EggBotBoard (EBB) www.schmalzhaus.com/EBB
 v1.2 12/01/2009
 by Brian Schmalz
 of Schmalz Haus

Title	EBB_v12
Version:	
	12/20/2009 4:33:45 PM
Drawn By:	1/1

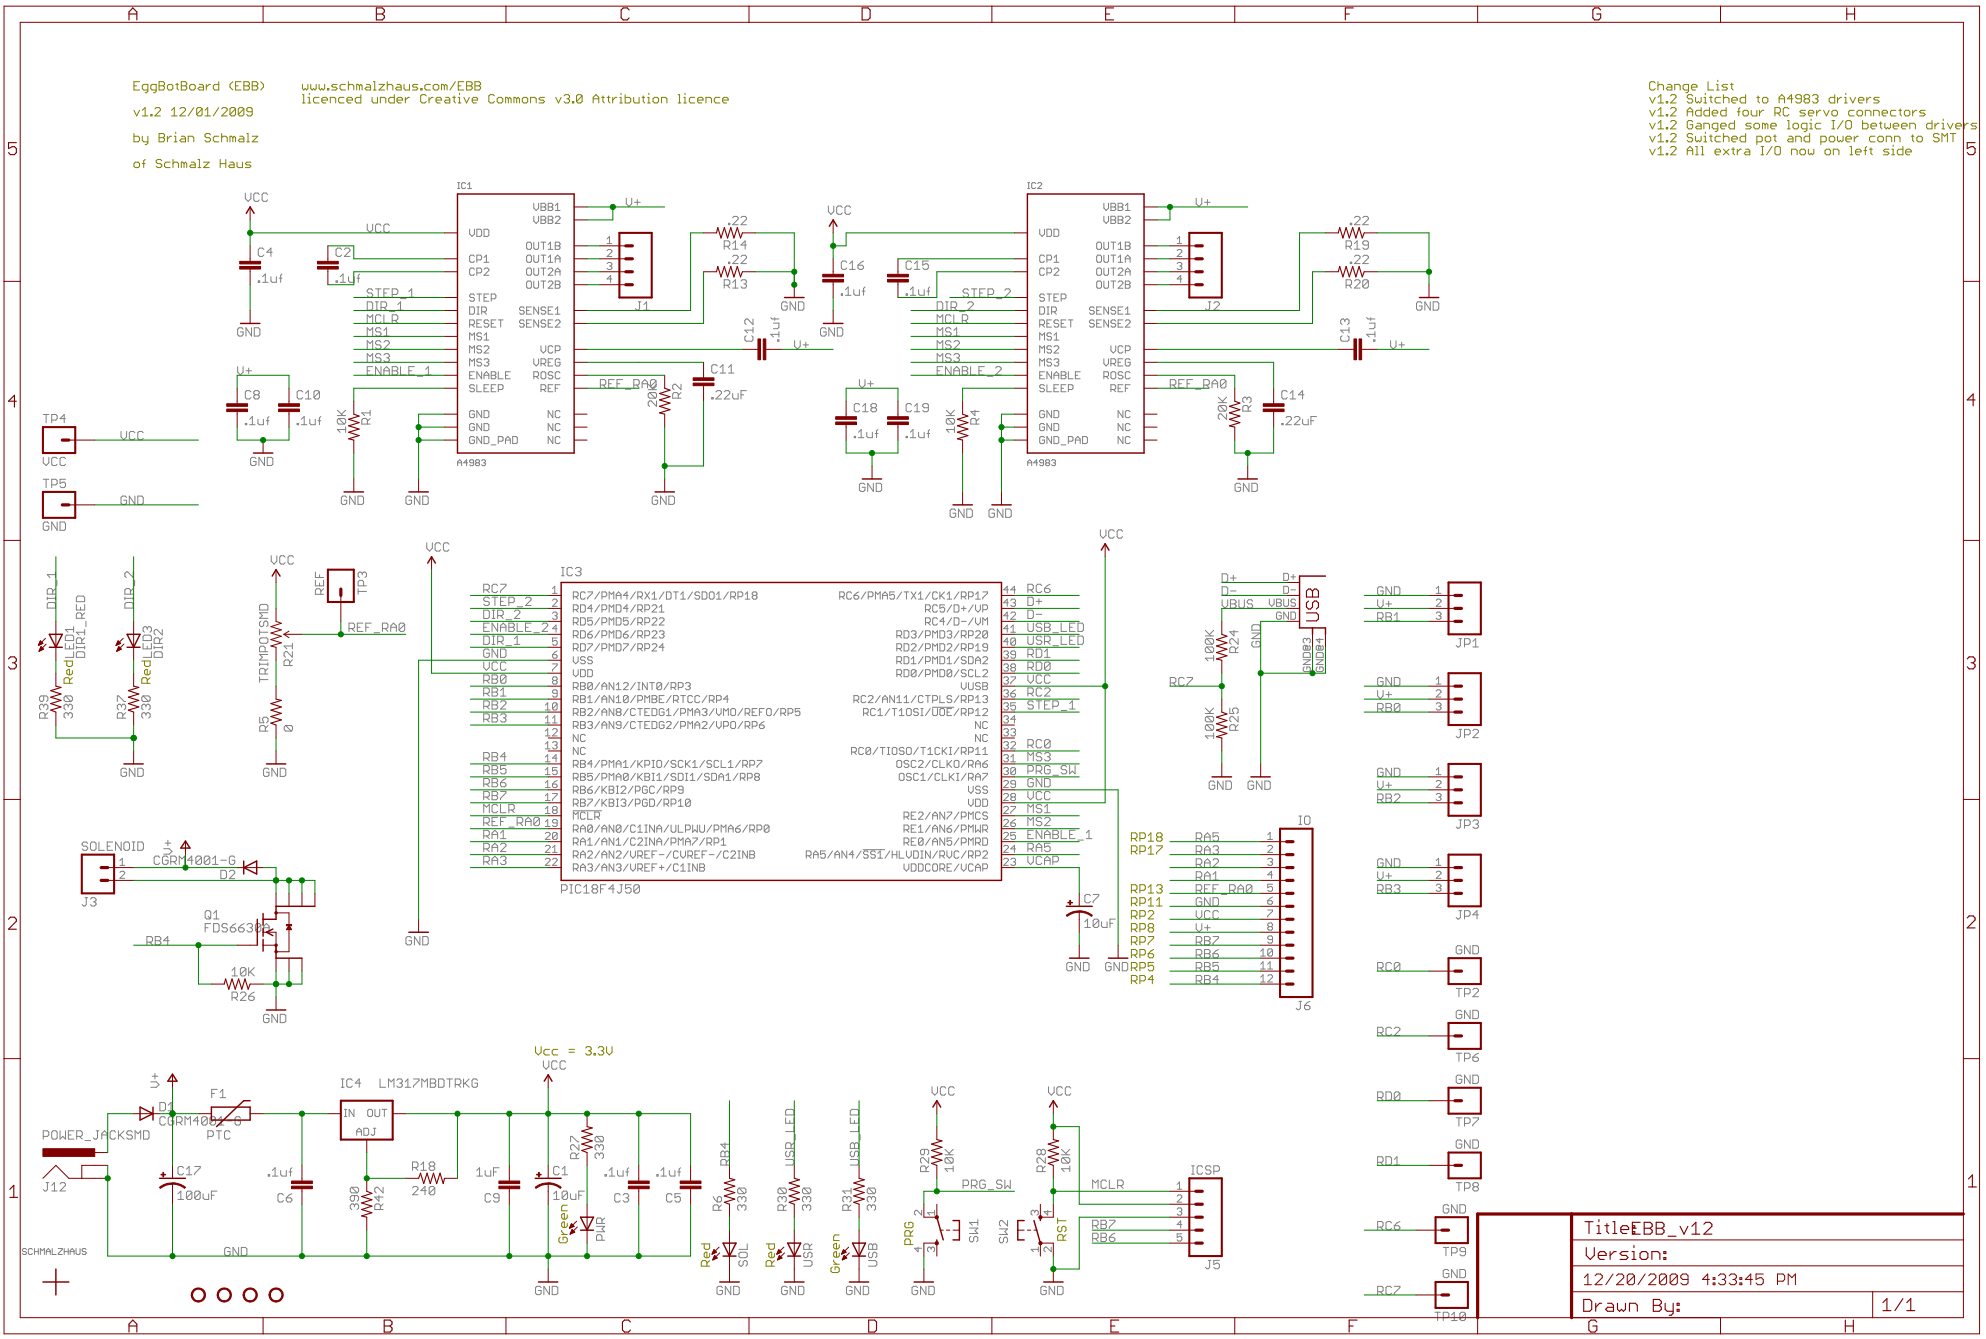
Change List
 v1.2 Switched to A4983 drivers
 v1.2 Added four RC servo connectors
 v1.2 Ganged some logic I/O between drivers
 v1.2 Switched pot and power conn to SMT
 v1.2 All extra I/O now on left side
